# 3505 South Bennett Street

MUP Recommendation Packet | Project #3029506 | January 29, 2019

**b9** architects

① View looking Southwest at Rear Facade

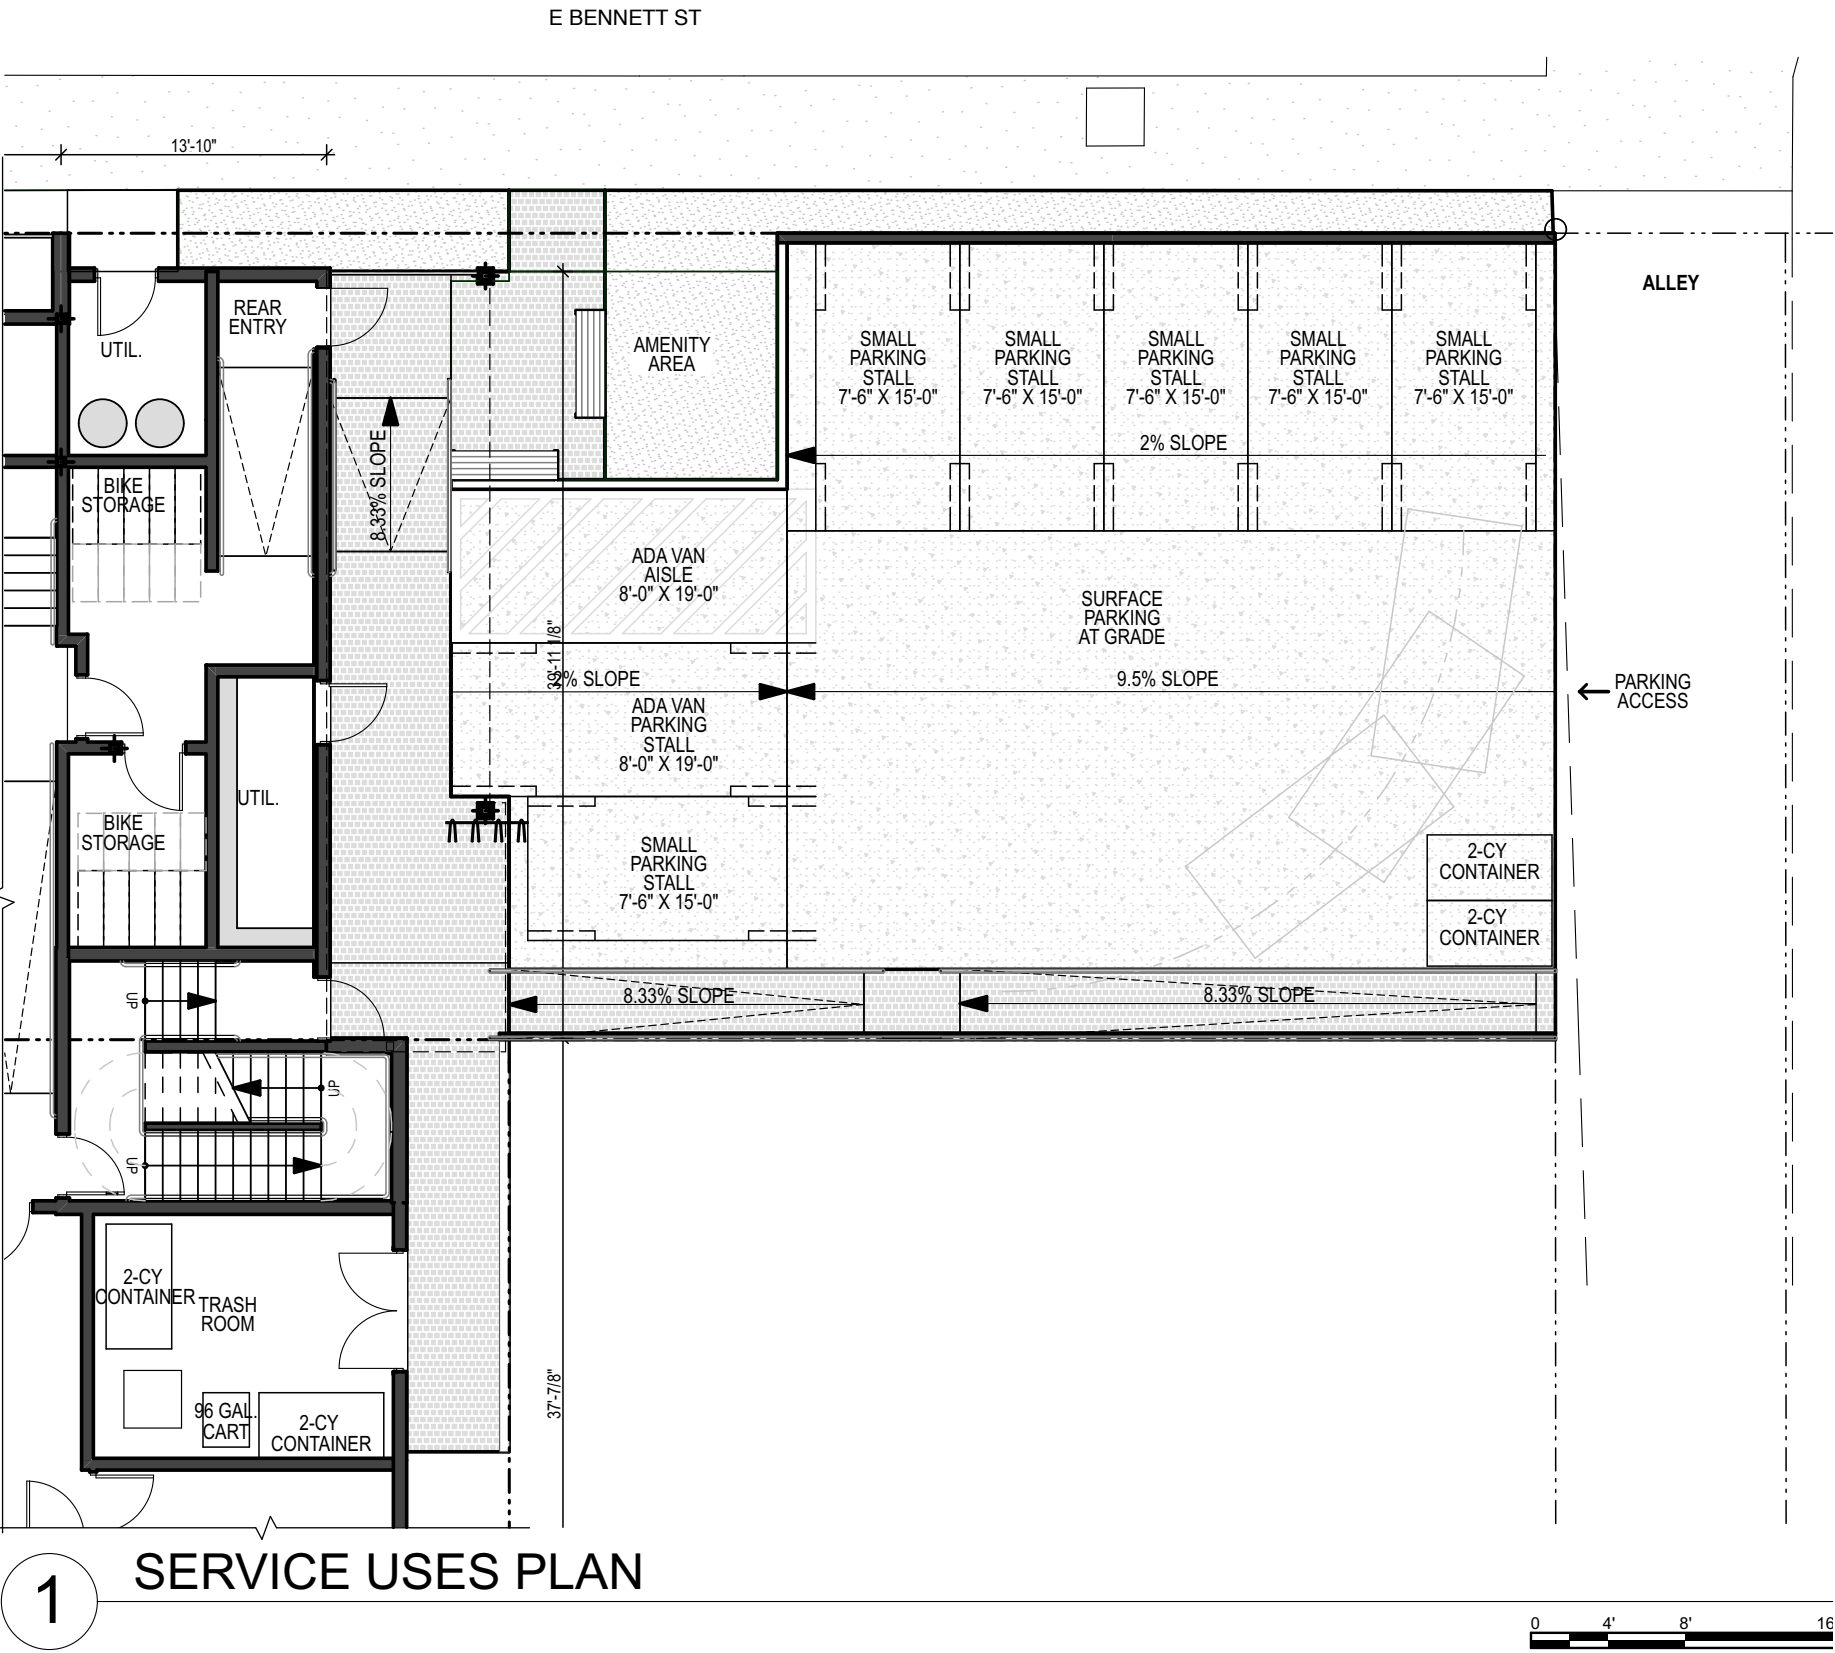
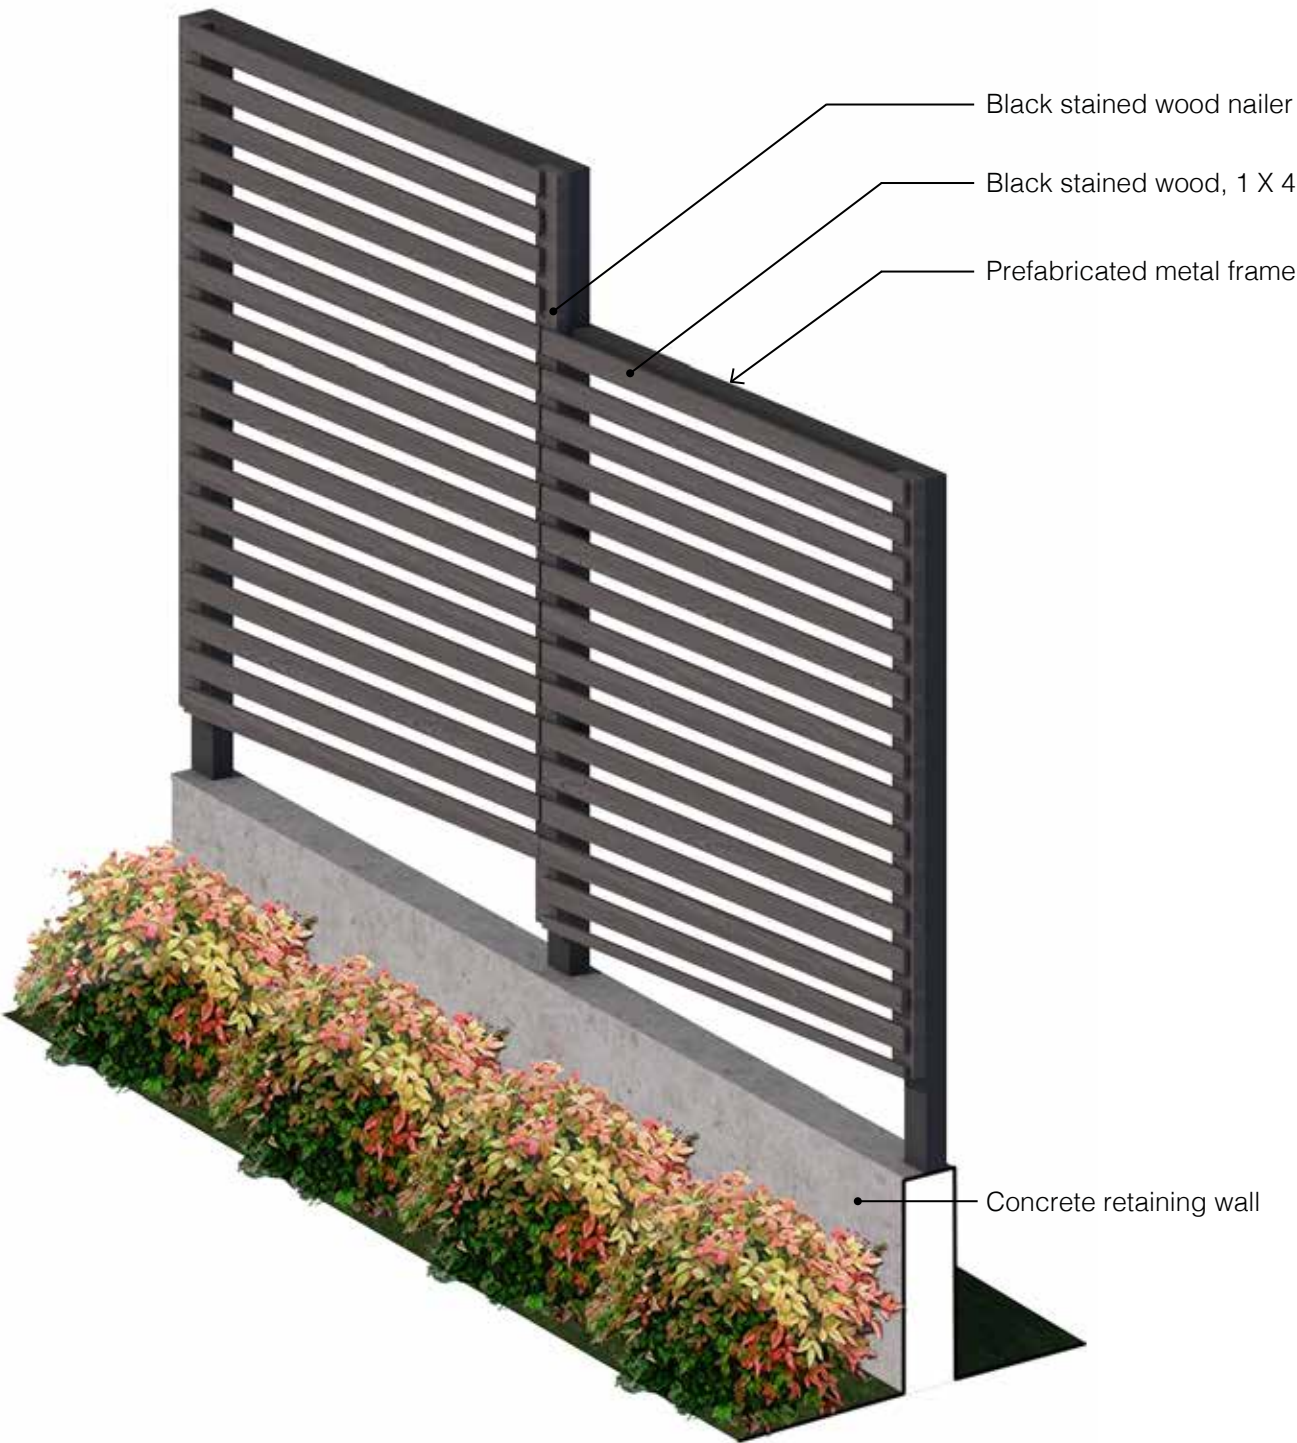
*a. In agreement with public comment, the Board was concerned with trash storage, staging, and service. The Board indicated they would be open to a departure from landscape buffer requirements along the alley, provided that the resulting design created a trash staging area and contributed to an attractive transition.*

- In response to the Board and public comment, the project created a trash staging area along the alley, accessed from S Bennett Street. It is located in the required five-foot landscape buffer which results in a departure being requested.
- An attractive transition is created through a combination of screening elements and landscaping around the trash staging area and surface parking. This strategy limits the visual impact of the trash and its storage to adjacent neighbors.
- Seattle Public Utilities has reviewed the staging strategy and provided formal approval of the proposal.

2 View looking Southeast at Parking Screening along S Bennett St

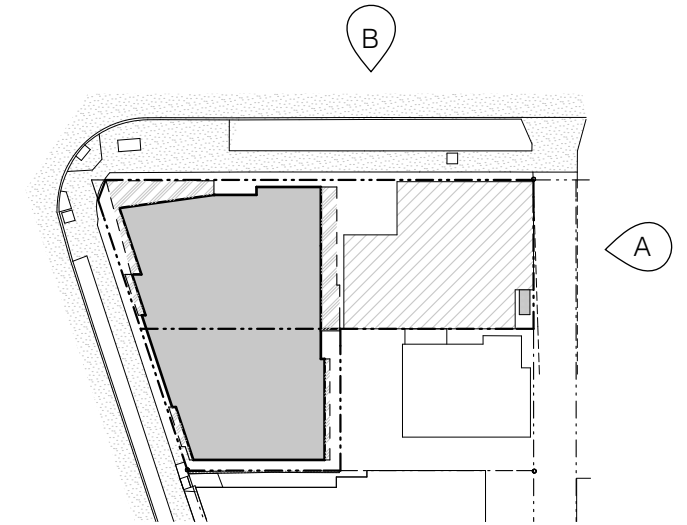
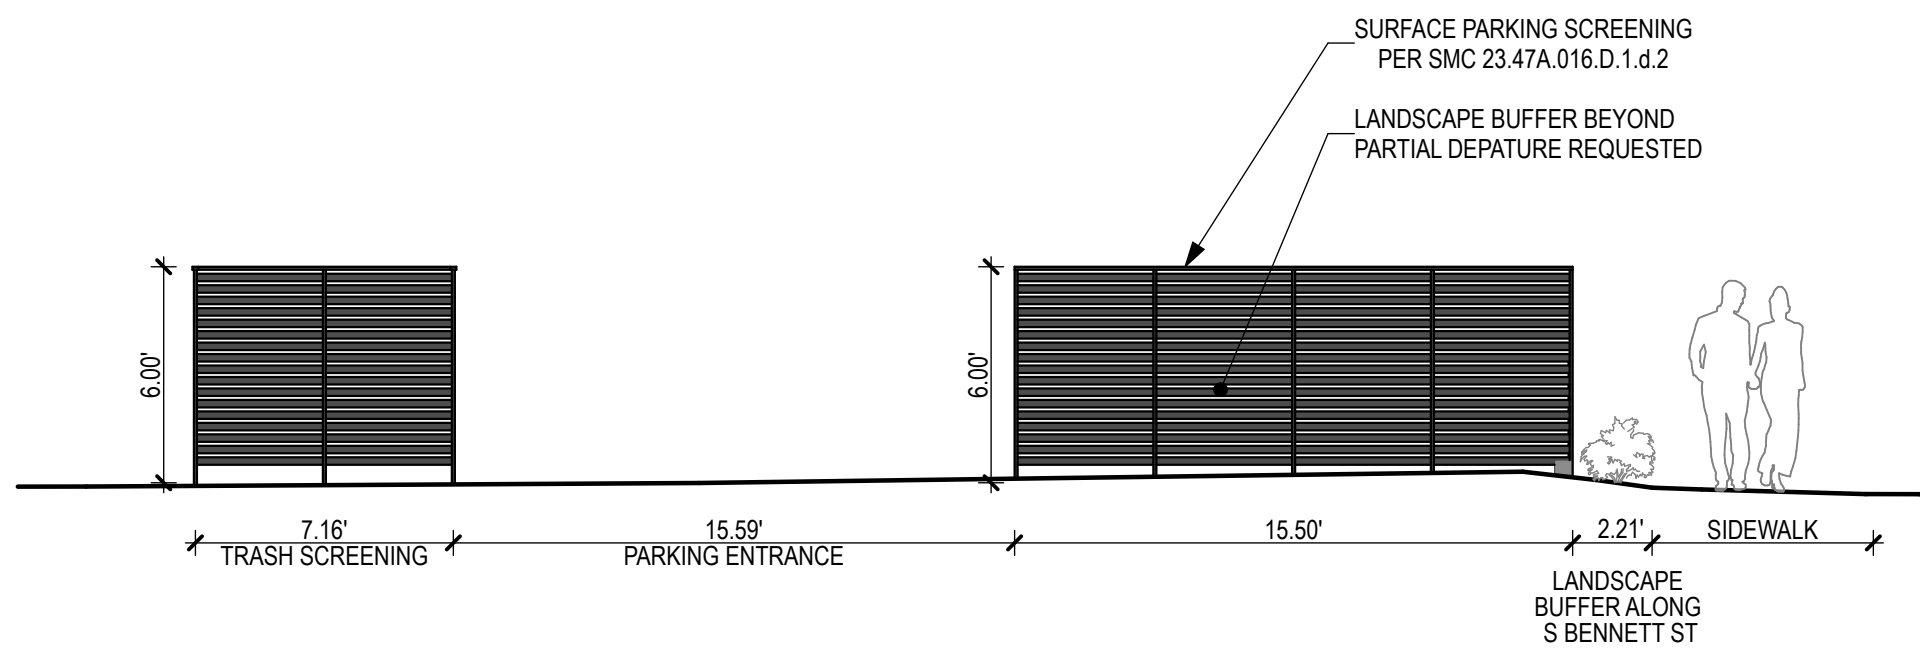
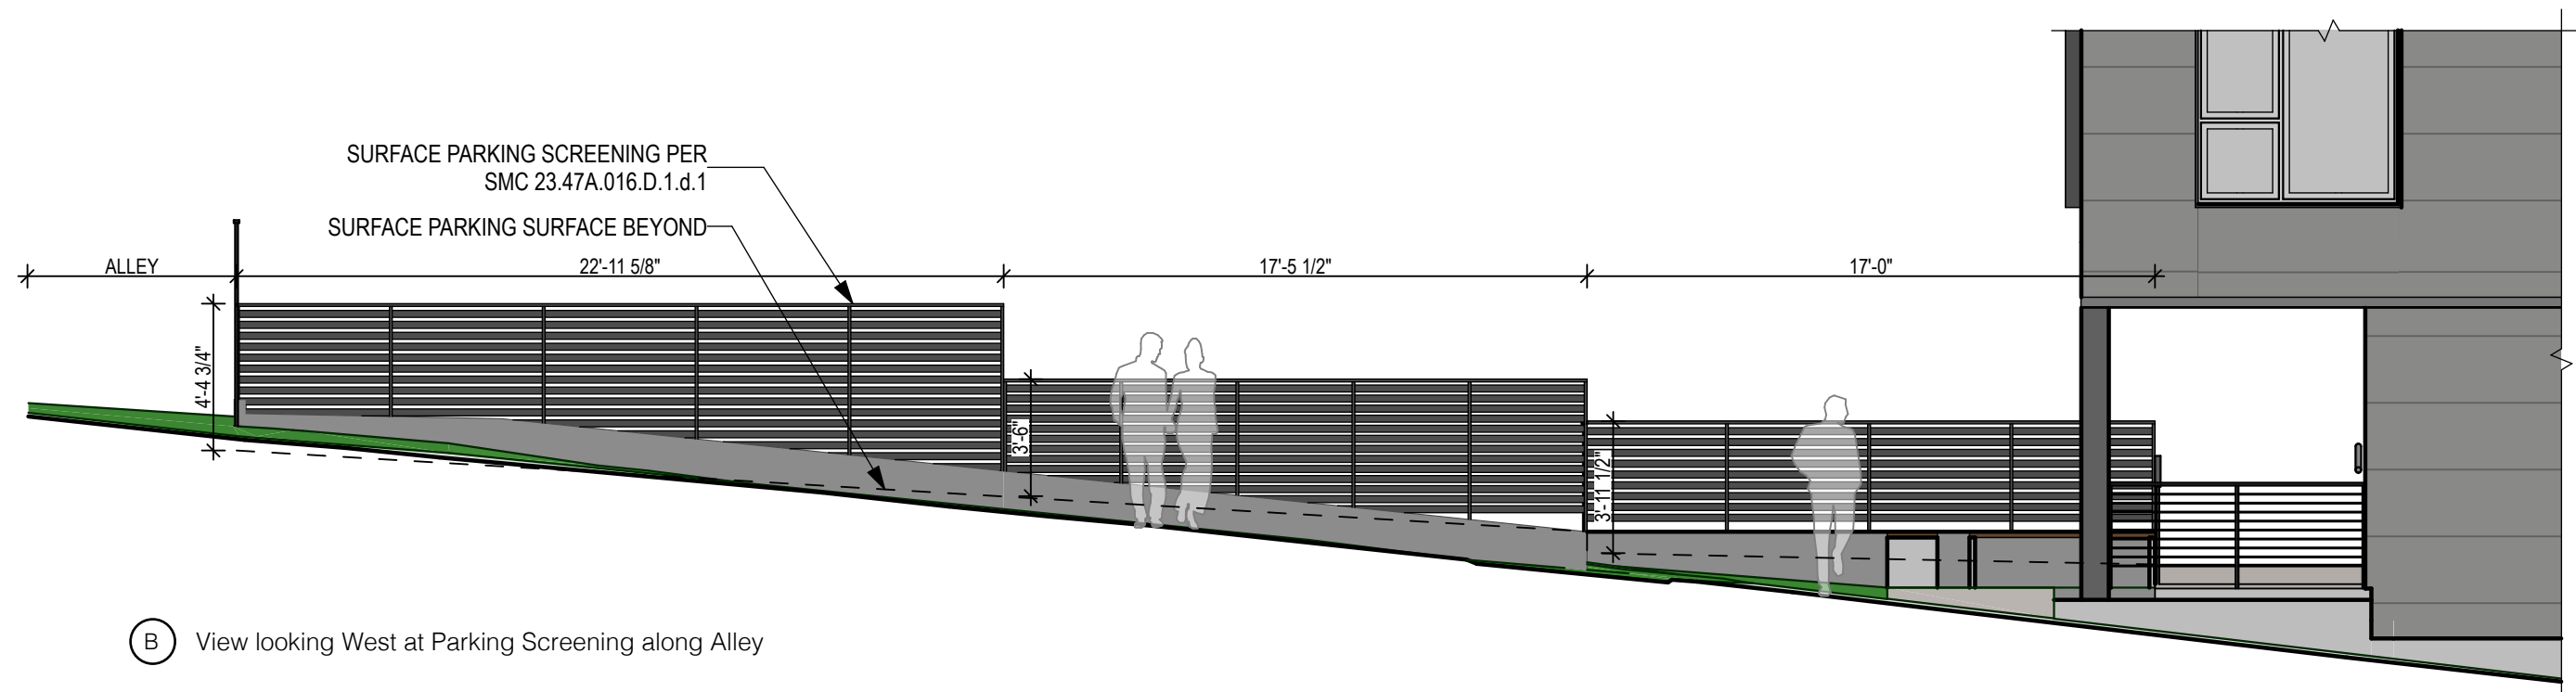
*b. The trash storage area should be attractively screened to minimize impacts on building aesthetics and the pedestrian experience.*

*c. The Board was concerned with the high visibility of the parking area, and visual impacts on the pedestrian realm. The Board directed further development of a screening concept which includes attractive material and landscape treatments that relate to the overall design.*

- The proposed trash staging area is screened with a 6'-0" tall powder coated metal frame with wood screening, consistent with other screening elements in the project. Refer to response to Item "a" above.
- In response to the Board's concern, the proposed parking area is screened along S Bennett Street and the alley.
- A 6'-0" powder coated metal screen will be constructed with high quality materials and will incorporate landscape treatments. The design is integrated into the overall design of the building and site concept.
